CARDINAL CREST HOMES
Scout 3 Bdrm Spec
1036 SW Armie St, KC, MO

STRUCTURAL REVIEW
HD ENGINEERING & DESIGN
HD: 40013 DATE: 7/14/2021

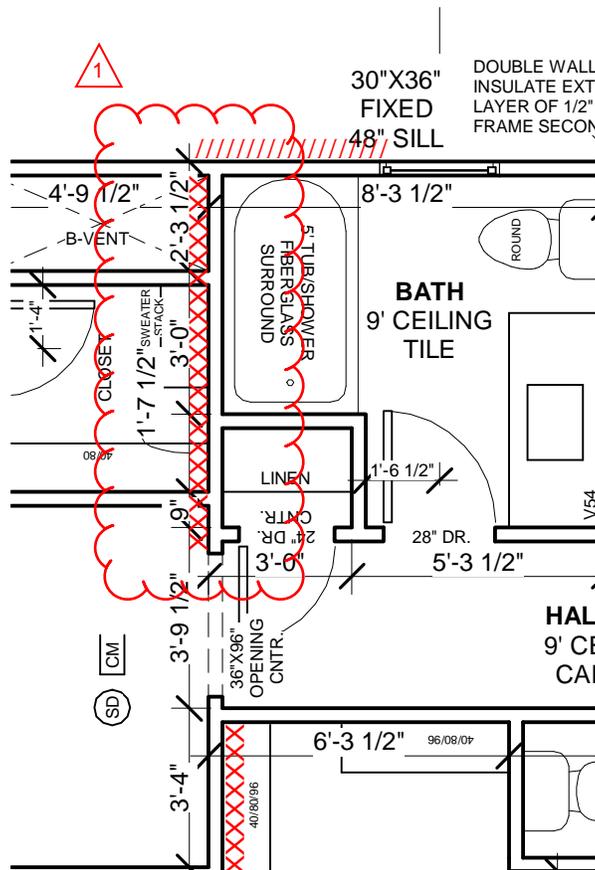
Our firm has been asked to make a structural recommendation for the house being built at the address listed above. The builder has informed us that during the rough in inspection the city has questioned the wall bracing behind the tub/shower insert.

After reviewing this item our firm recommends screwing the opposite side of the wall with the GB method as shown on the approved plans. The GB bracing should extend as shown on the sketch attached.
